Urgent Field Safety Notice

Pipeline™ Vantage Embolization Device with Shield™ Technology

Recall of 027 Compatible Devices (PED3-027-XXX-XX)

IFU Update to 021 Compatible Devices (PED3-021-XXX-XX)

Figure 3. Illustration of landing zone and aneurysm neck

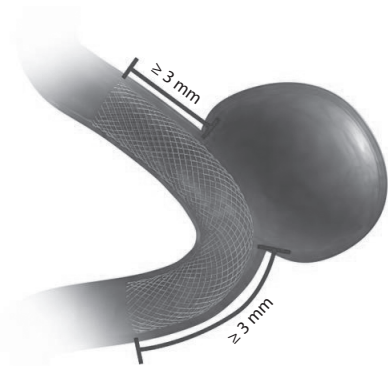
- Choose a Pipeline™ Vantage device with labeled length that is at least 6 mm longer than the aneurysm neck and **≥ 3 mm landing zone on both sides of the aneurysm neck, see Figure 3.**

- Verify that the distal and proximal landing zones are both ≥ 3 mm and not under tension, see Figure 3. If less than 3 mm or under tension such that the device may foreshorten in a way that the landing zone is less than 3 mm, consider deployment of an additional device in a telescoping manner, such as an overlapping Pipeline™ or other neurovascular flow-diverting stent to ensure adequate securement of the ends of the implant.
